County of Fairfax, Virginia

STAFF REPORT

APPLICATION RZ 2010-MV-011

APPLICANT: Memorial Venture, LLC

GENERALIZED DEVELOPMENT PLAN - SINGLE BUILDING OPTION
 LOTS 117 THROUGH 130, 138 THROUGH 140
 BLOCK 'D'
 MEMORIAL HEIGHTS
 MOUNT VERNON DISTRICT
 FAIRFAX COUNTY, VIRGINIA

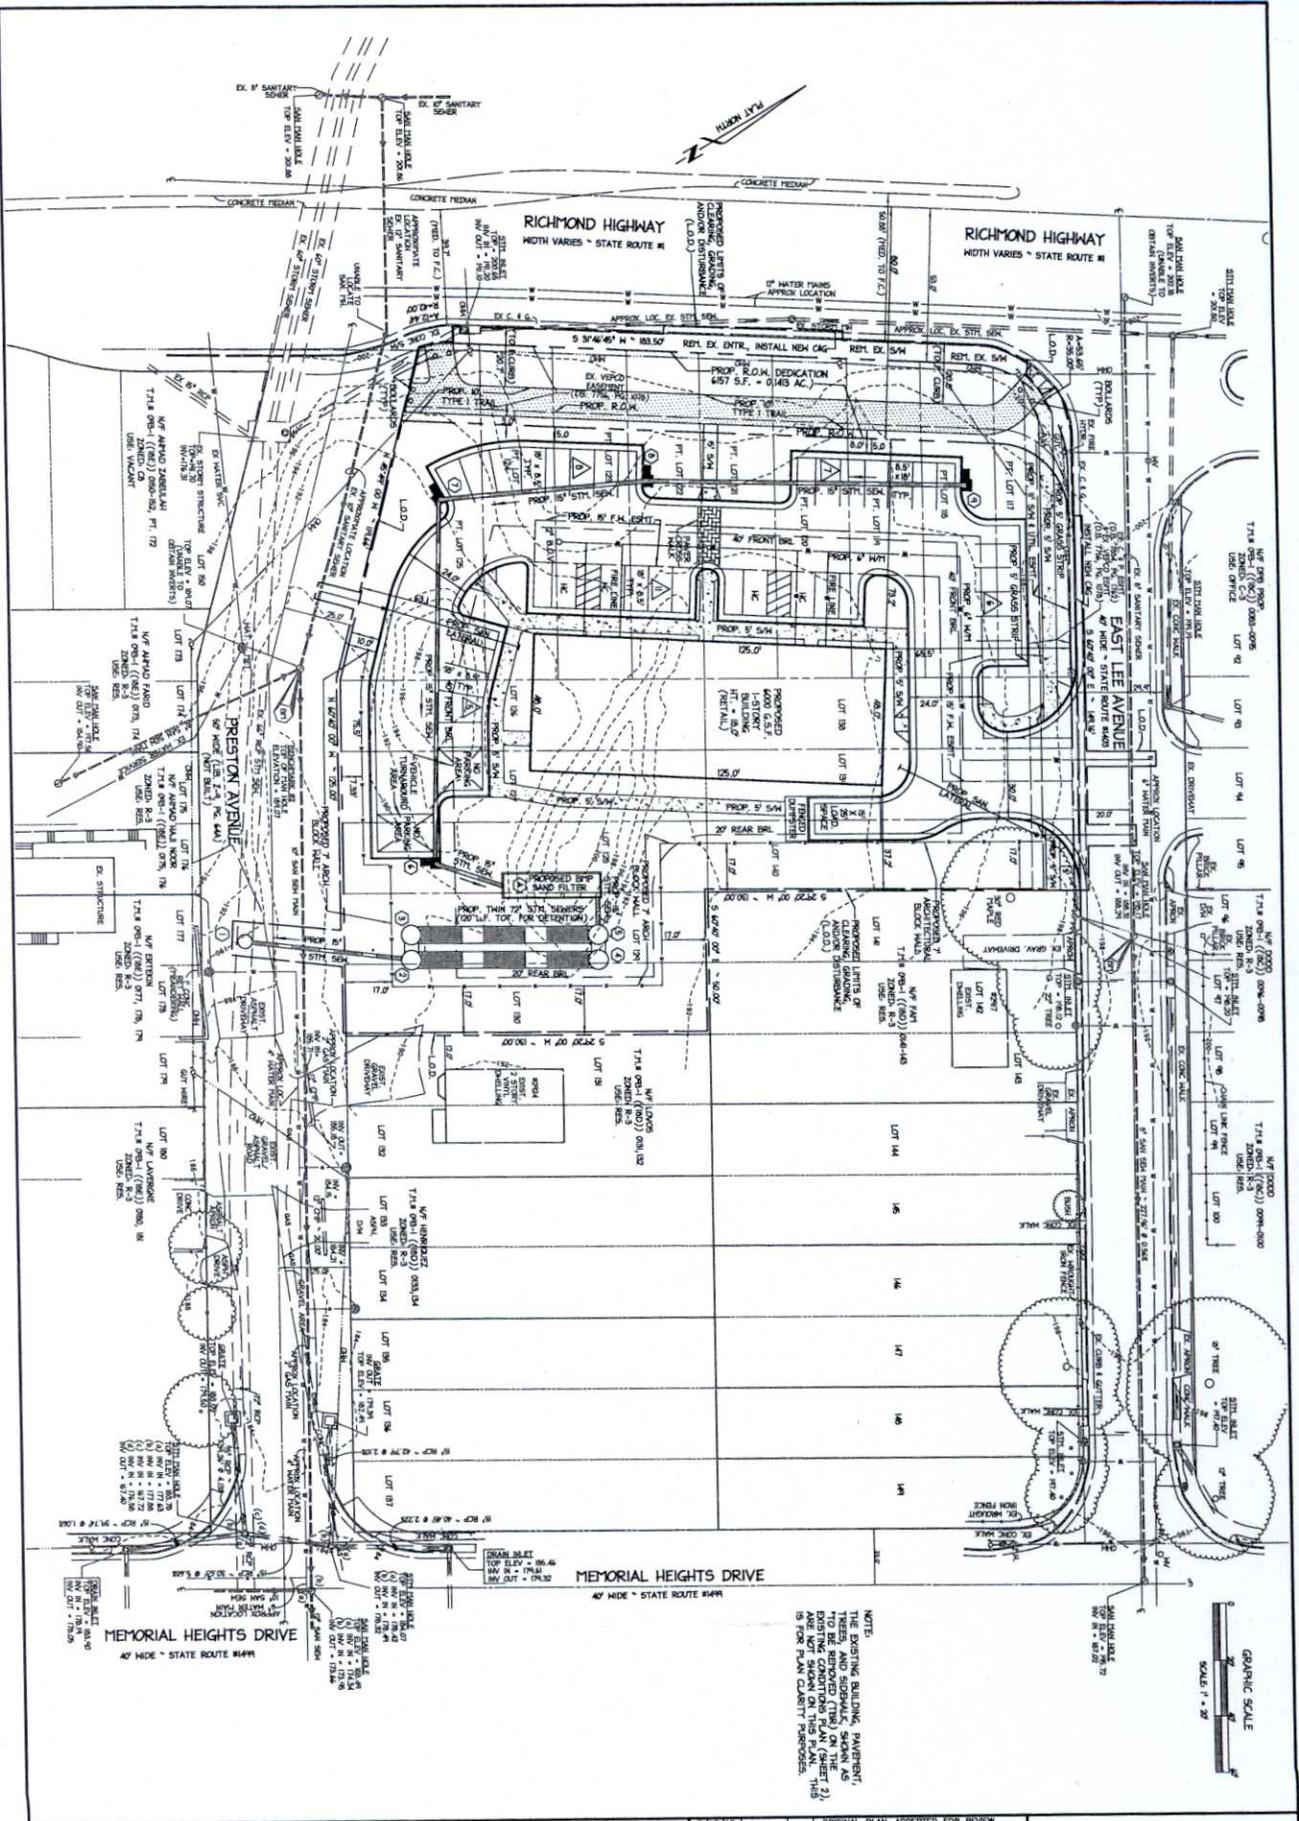
The GDP also shows two design options for the proposed shopping center; either two 3,000 SF buildings or one 6,000 SF building with a floor area ratio (FAR) of 0.11. The applicant has stated that they will only construct the single 6,000 SF building if by the site plan stage they do not have the required number of tenants to lease commercial space in both buildings. Even though staff requested an exhibit of the single building option, the applicant has not provided staff with such an exhibit. Staff recommends that a proffer be included that stipulates the architectural design for the single building option will resemble the design for the two building option.

LANDSCAPING / TREE COVER PLAN
LOTS 117 THROUGH 136, 138 THROUGH 140
BLOCK "D"
MEMORIAL HEIGHTS
MOUNT VERNON DISTRICT
FAIRFAX COUNTY, VIRGINIA

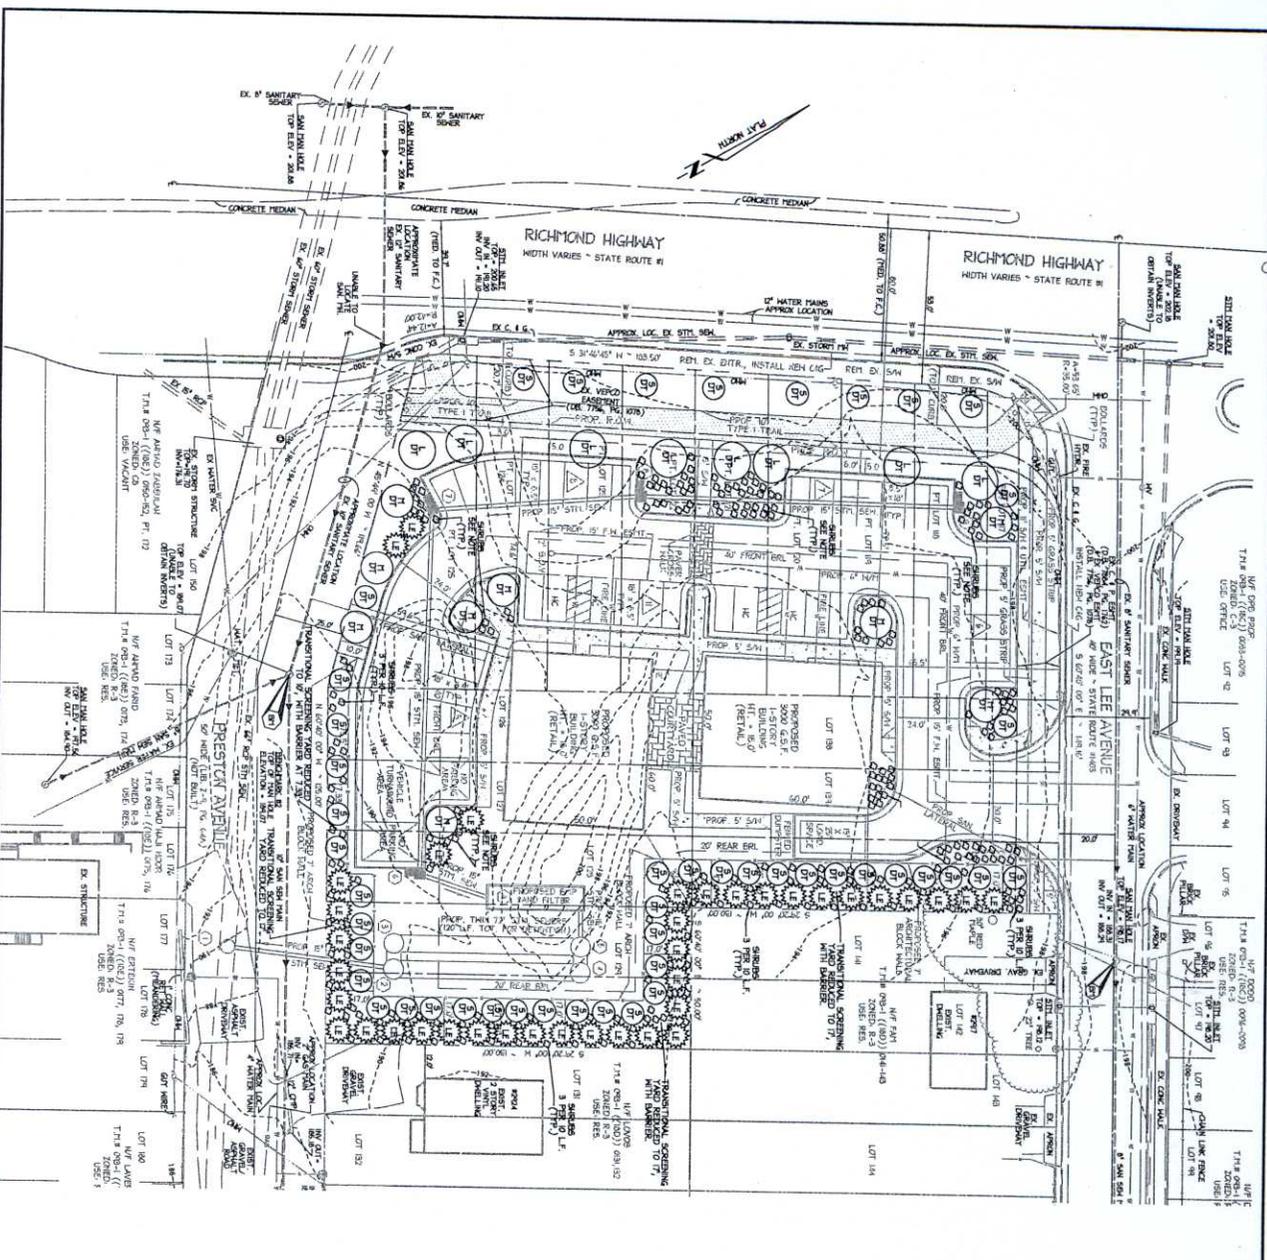
Urban Forest Management Division (UFMD) staff has noted that a tree located on the abutting residential property to the east would be directly impacted by the proposed development as the proposed limits of clearing and grading would remove approximately half of the tree's root system. As a result, the tree may become a hazard to the public at large, as well as to the applicant's and owner's property. Staff advised the applicant to hire an ISA Certified Arborist or an ASCA Registered Arborist to conduct a condition analysis and provide the information for staff to review. The applicant stated that an arborist was hired and it was determined that the tree is in poor health. Staff also advised the applicant to contact the adjacent property owner to inform him of their findings and to determine whether or not the property owner would be agreeable to removal of the tree. Staff was recently informed that the applicant has contacted the adjacent property owner who has agreed to the tree's removal. Staff is

The applicant proposes no tree preservation on-site. UFMD staff notes there is some quality vegetation on-site that could be preserved. However, preservation of these trees would preclude the site from development as they are located in the center and at the northern end of the site where the buildings, travel aisles, and parking are proposed to be located. Even if the site design is modified by shifting the building(s) towards the front of site, the trees cannot be saved. Staff informed the applicant that a deviation from the tree preservation target requirement could be pursued; the applicant has revised the GDP to include such a request. However, the deviation request is incomplete as no justification has been provided. UFMD staff has stated that they would support the deviation request if the appropriate justification is provided at site plan.

Exhibit 3a: Proposed Site Design for Two Buildings

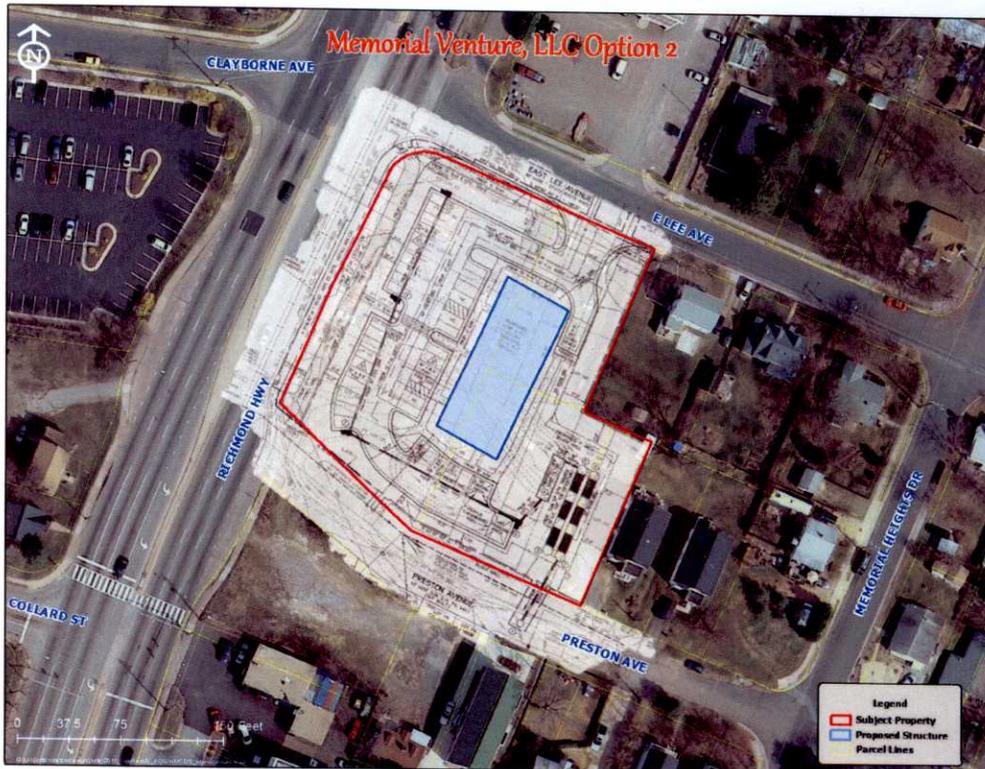
Site Layout: The GDP depicts a 6,000 SF, one-story shopping center comprised of either two 3,000 SF buildings or an optional design containing one 6,000 SF building (to be determined at site plan) with a floor area ratio (FAR) of 0.11 located towards the rear of the site. In the applicant's third proffer it states that the applicant reserves the right to shift the square footage between the buildings at site plan provided there is no decrease in open space and/or the building setbacks. The architectural exhibit (see Exhibit 4) depicts the building materials for the structure(s) to include brick, glass, metal panels, and precast concrete. Black awnings are depicted above the glass doors and windows. The applicant states that the shopping center would accommodate up to six retail units within the building(s). Thirty-seven parking spaces are depicted on the GDP, with 26 parking spaces proposed at the front of the site between the building and the Richmond Highway frontage; six parking spaces to the north along the Preston Avenue frontage, and five spaces along the south side of the building that faces Preston Avenue.

Additionally, the GDP depicts a five-foot wide concrete sidewalk connecting the proposed 10-foot wide trail along the Richmond Highway frontage to a five-foot wide sidewalk that goes around the front and sides of the two buildings. A five-foot wide sidewalk approximately 30 feet long is also proposed at the rear of the northernmost building. On Sheet 3B which depicts the single 6,000 SF building option, the sidewalk at the rear of the building is proposed for almost the full length of the structure.
